Proposal No. 609409-133236

March 26, 2026

**ADDENDUM NO. 4**

**SPRINGFIELD**  
**Federal Aid Project No. HIP(NGB)-003S(924)**  
**Bridge Replacement, S-24-016, Armory Street over CSX Mainline**  
**& S-24-026, Armory Street over Abandoned CSX**

**DRAINAGE & UTILITY PLAN  
SHEET 2 OF 2**

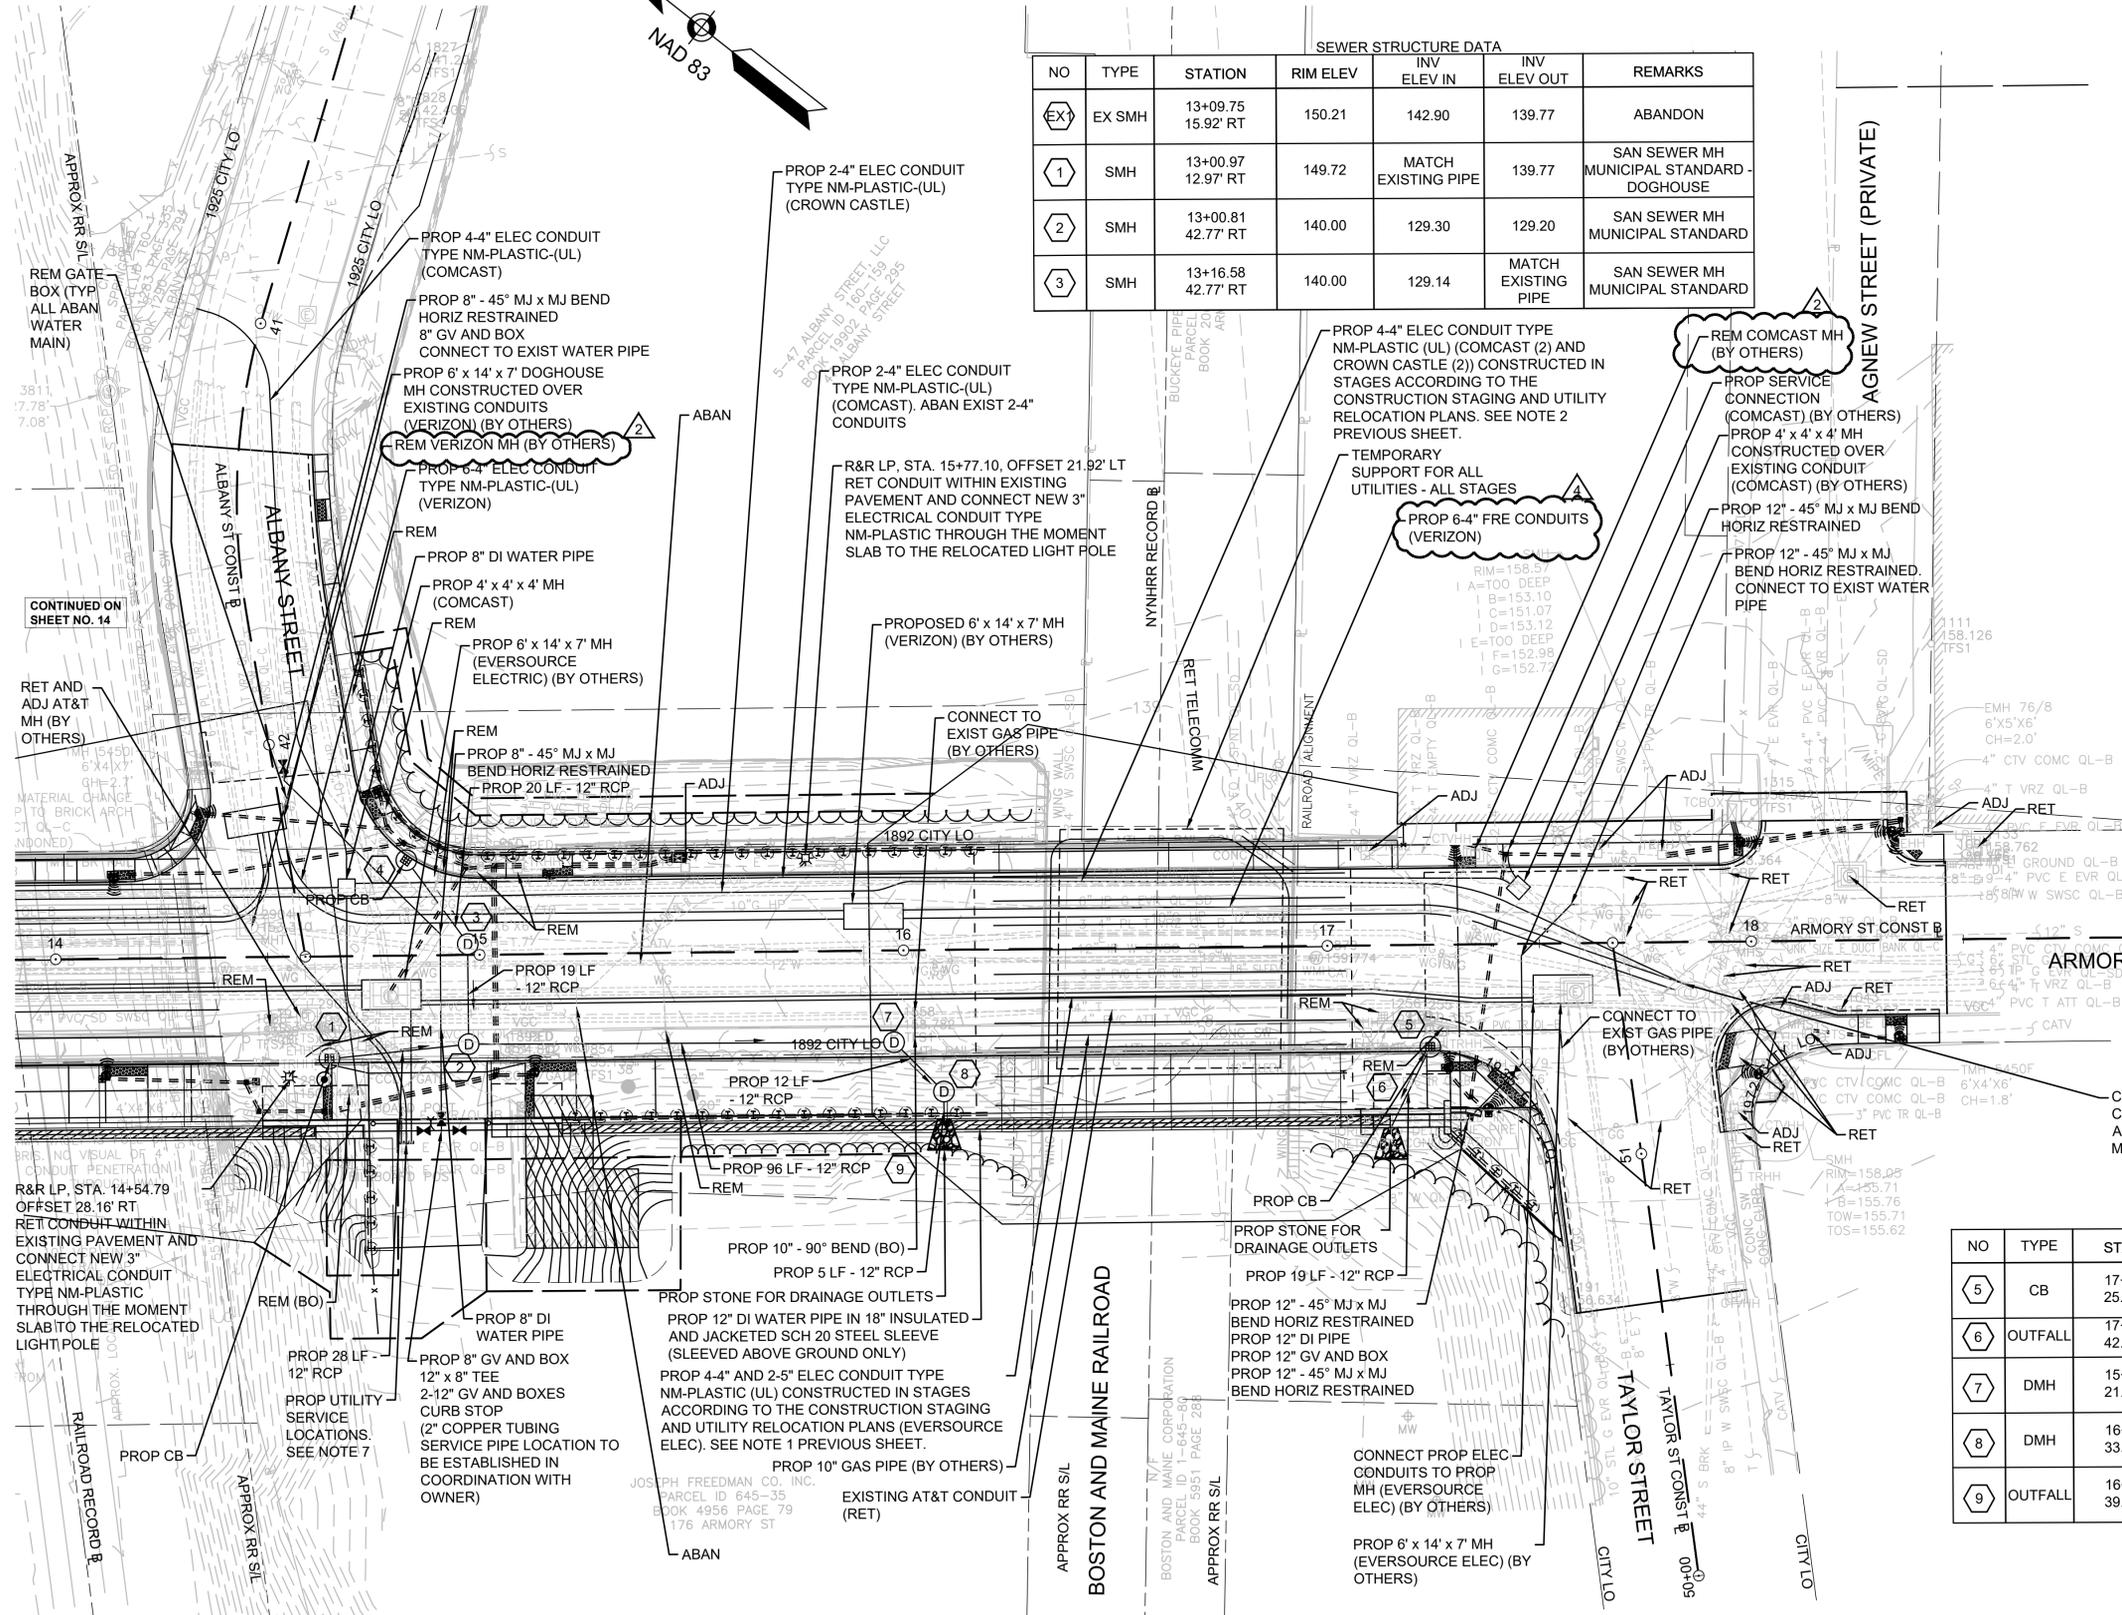
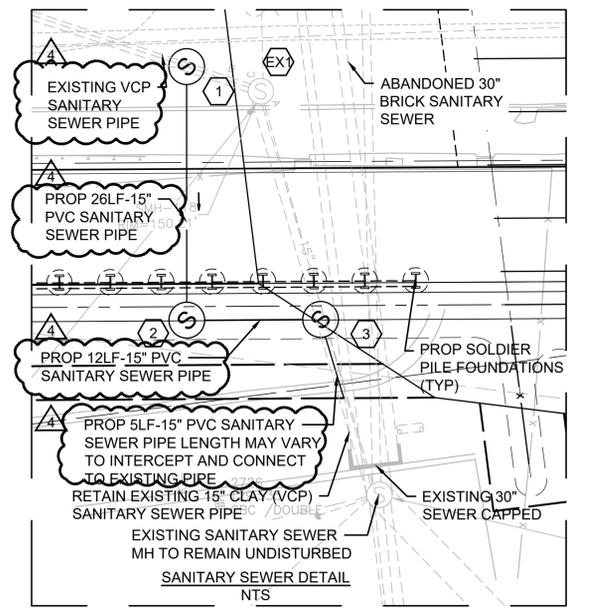
Question 49) Refer to bid item 250.15 “15 Inch Polyvinyl Chloride Sanitary Sewer Pipe.” While the spec. item is for 15” PVC, drawing detail Insert A of Sheet 15 shows 12” PVC for proposed sewer line. Please clarify the size of piping that passes through the soiler pile wall.

Response 49) See revised plan sheet 15 of 204.

**CONSTRUCTION STAGING AND  
UTILITY RELOCATION PLAN  
STAGE 2  
SHEET 2 OF 2**

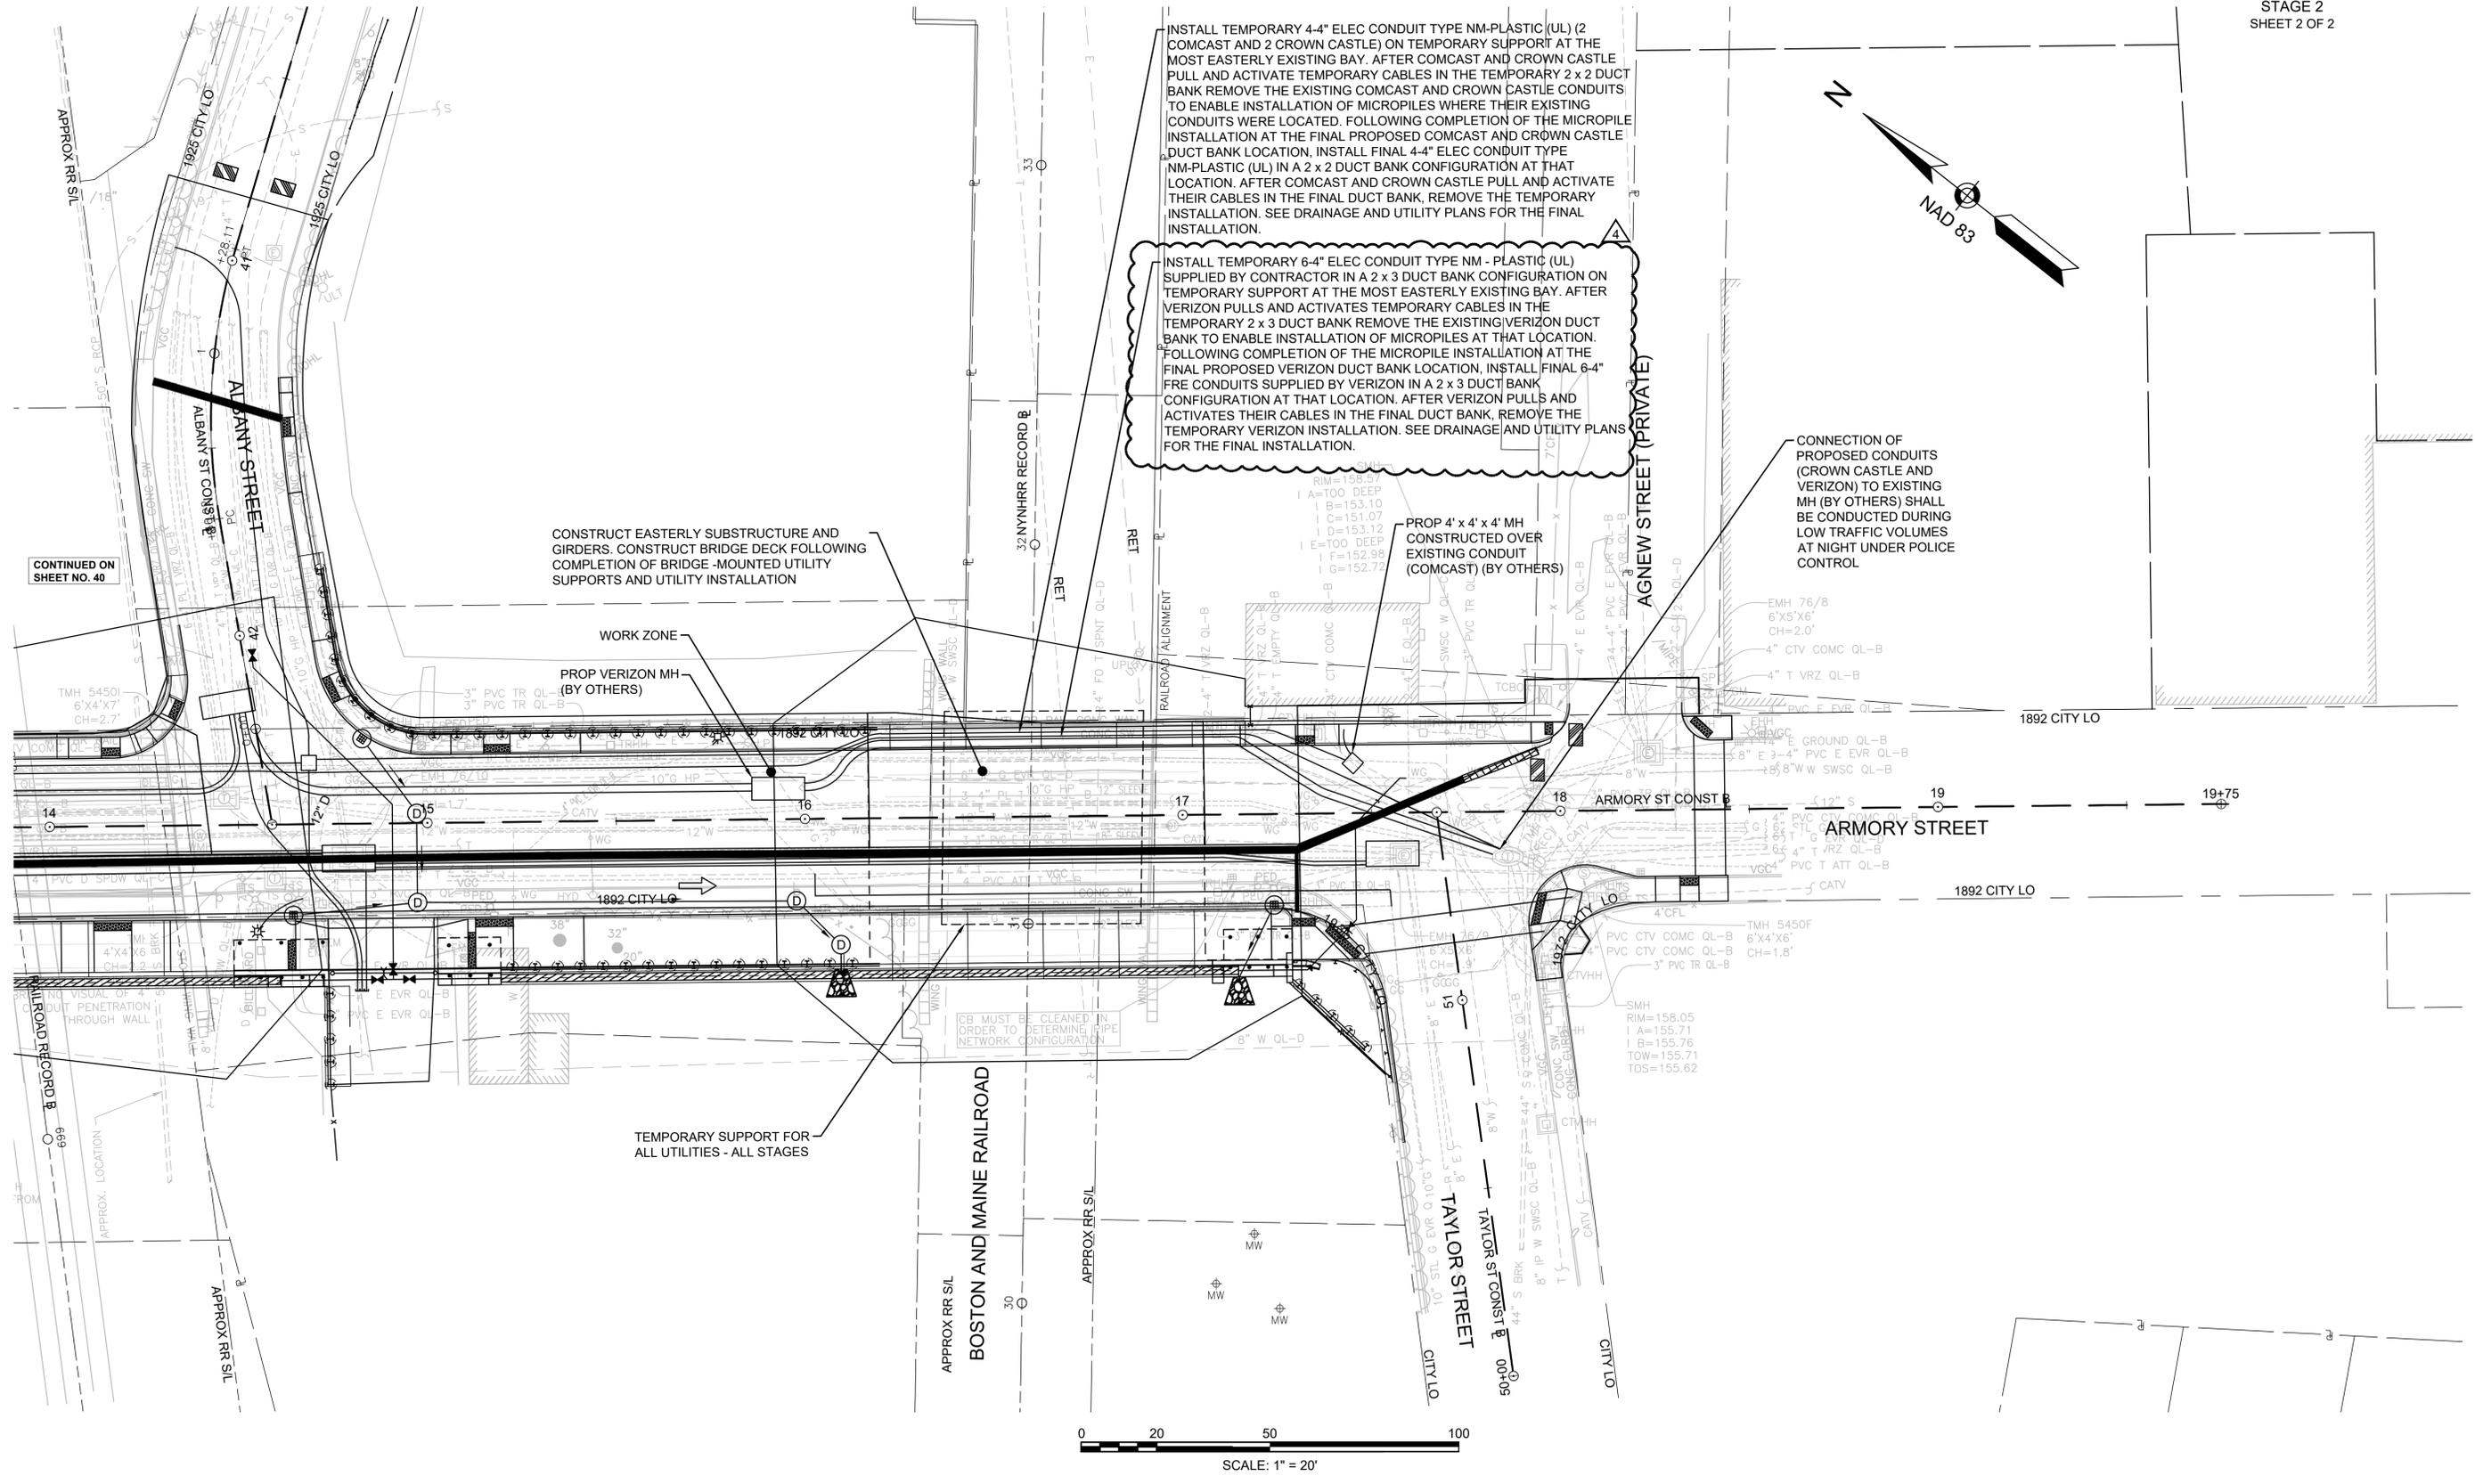
Question 52) Note on Contract Drawing Sheet No. 41 of 204 states that Verizon (VZ) will provide six (6) 4" FRE conduits for both the temporary and final configurations for the Contractor to install. The conduits for the other utilities (Comcast, Crown Castle, and Eversource Electric) are identified as Type NM (UL), furnished and installed by the Contractor for both temporary and final configurations. Please confirm these non-VZ conduits beneath the bridges is also intended to be Type NM (UL) rather than FRE and will be paid for under those Bid Items. If FRE conduits are required, please include the appropriate pay items.

Question 53) The note on Contract Drawing Sheet No. 41 of 204 and the PUC Form indicate that Verizon will provide six (6) 4-inch FRE conduits for both the temporary and final configurations for the Contractor to install. Please consider adding a pay item for this work.

Response 52) See new page A00801 - 153.1 and revised plan sheet 41. The only FRE conduits in the project are Verizon and Verizon will provide them to the project. All other conduits for all other utilities are Type NM.

INSTALL TEMPORARY 6.4" ELEC CONDUIT TYPE NM-PLASTIC (UL) SUPPLIED BY CONTRACTOR IN A 2 x 3 DUCT BANK CONFIGURATION ON TEMPORARY SUPPORT AT THE MOST EASTERLY EXISTING BAY. AFTER VERIZON PULLS AND ACTIVATES TEMPORARY CABLES IN THE TEMPORARY 2 x 3 DUCT BANK REMOVE THE EXISTING VERIZON DUCT BANK TO ENABLE INSTALLATION OF MICROPILES AT THAT LOCATION. FOLLOWING COMPLETION OF THE MICROPILE INSTALLATION AT THE FINAL PROPOSED VERIZON DUCT BANK LOCATION, INSTALL FINAL 6.4" FRE CONDUITS SUPPLIED BY VERIZON IN A 2 x 3 DUCT BANK CONFIGURATION AT THAT LOCATION. AFTER VERIZON PULLS AND ACTIVATES THEIR CABLES IN THE FINAL DUCT BANK, REMOVE THE TEMPORARY VERIZON INSTALLATION. SEE DRAINAGE AND UTILITY PLANS FOR THE FINAL INSTALLATION.
